Subject: BUS KNEEL HEIGHT
Applicable Products: SSR Series Products
Effectivity: 01/19/23

FIG. [1] LOCATION OF CAM FOLLOWERS. ONE ON EACH SIDE

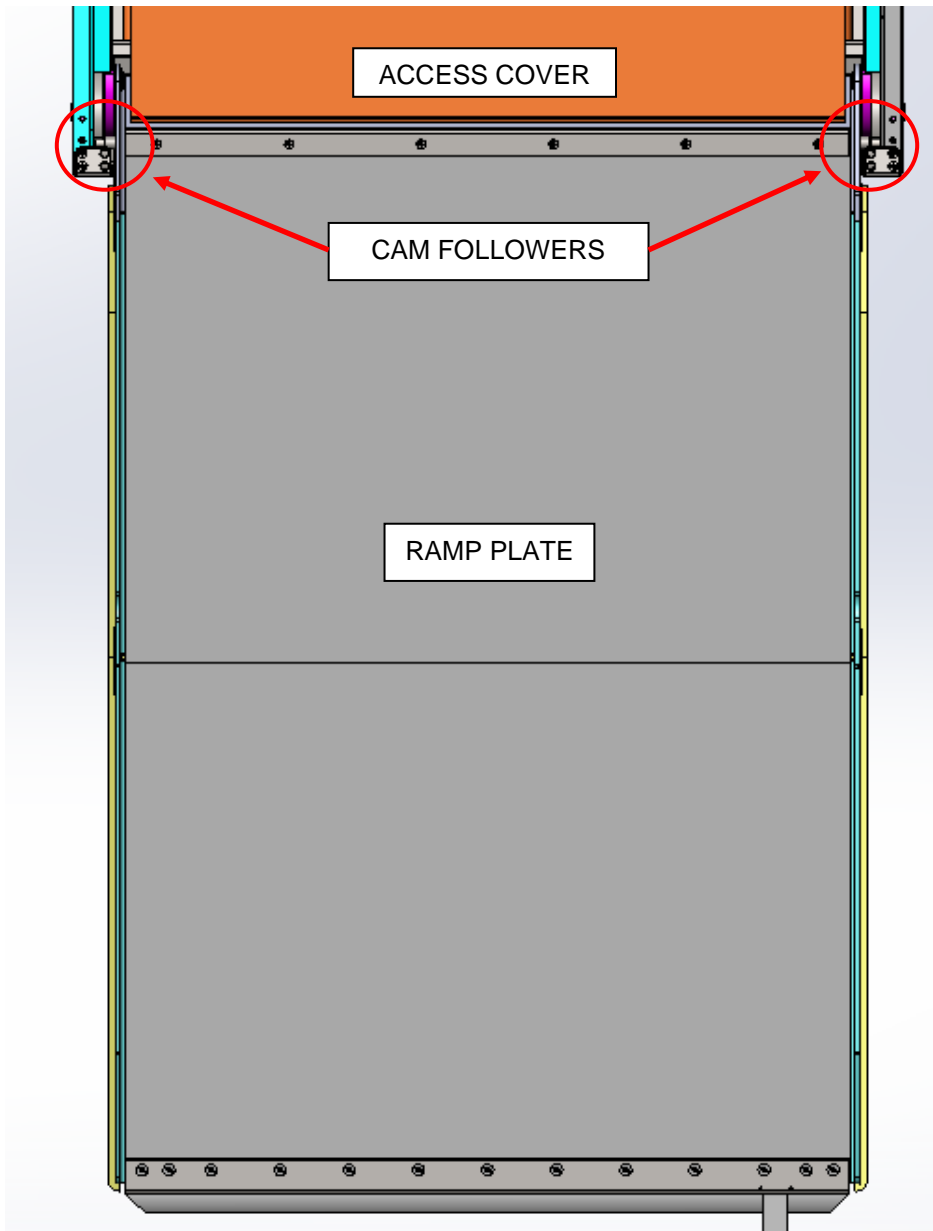
SSR ramps may experience mechanical failures of the ramp plate cam followers when the ramps are deployed to ground level from a bus ride height greater than 12".

SSR ramps have a max. floor height application of 12" to remain compliant with FMVSS and ADA slope requirements when deployed to ground. In applications where the ramp is deployed to the ground and the bus floor height is greater than 12", the bus needs to be knelt so that the bus floor height is 12" or less. Deploying the ramp to ground at a floor height greater than 12" may damage the cam followers if the ramp is loaded with a passenger.

Operators must be trained to kneel the bus to lower the bus floor height when deploying the ramps to ground level. To prevent damage to the ramp plate cam followers, kneel the bus every time the ramp is deployed to ground on vehicles with a ride height greater than 12". Inspect and replace the cam followers if damage is observed.

FIG. [2] CLOSE UP OF LEFT SIDE CAM FOLLOWER

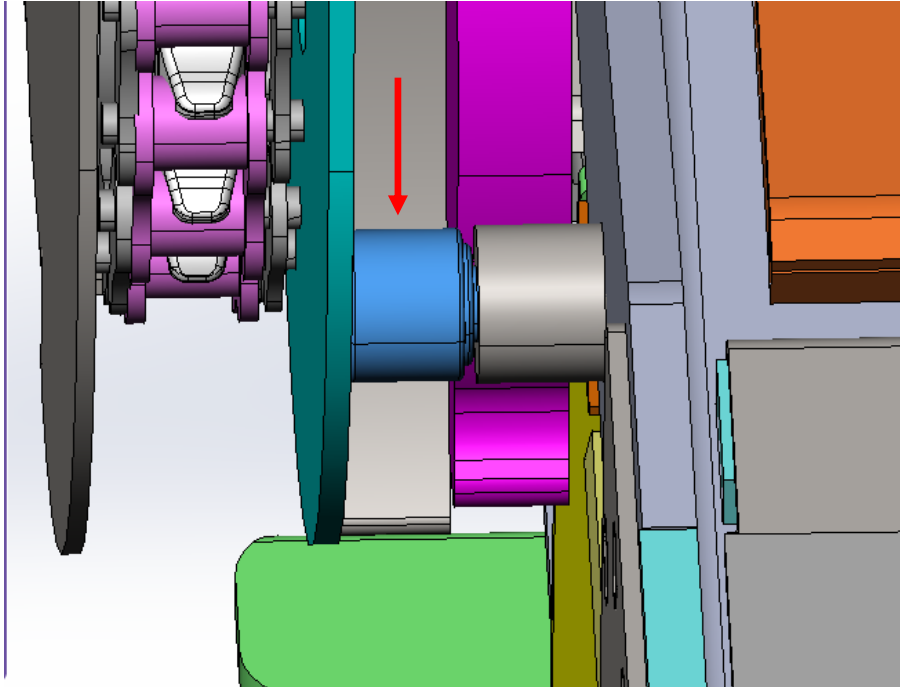
Failure of the cam followers may include; breakage, separation, or fracture of the bearing surface, bending of the mounting studs, and shearing of the cam follower shaft. Failure of the cam followers can also affect the operation of the ramp and damage other mechanical components.
